Subject: Question and Answer (Q&A) Correspondence No. 1

Reference: Request for Quotations (RFQ) No. 19JA80-20-Q-0723
Gym Locker Room and Bathroom Restoration Services

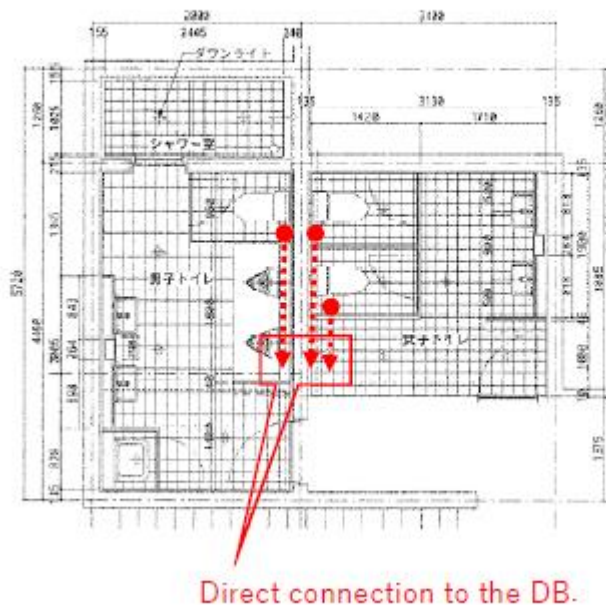
Please let us know the distance from toilet chambers to the Distribution Box (DB).

Or, indicate the existing DB location on the plan drawing.

- Each electrical wiring for the future shower toilet to be connected directly to the DB.

The existing Distribution Box (DB) is located in the ceiling over cleaner's basin. Please use the DB as primary source. Behind a wall near female toilet's chamber, a DB is installed on a wall of

Gym Weight Room. AC100V is available.

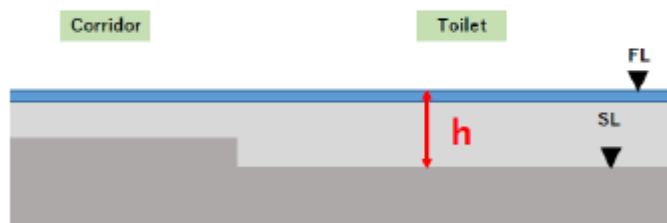
h : How much ?
Or, please submit a section dwg.

h : How much ?

Or, please submit a section dwg.

A gap between floor tile surface and concrete slab is thought to be 30mm-40mm in such building build in early 80's and the bidding winner shall fine-tune by adjusting thickness of bonding agent, etc.
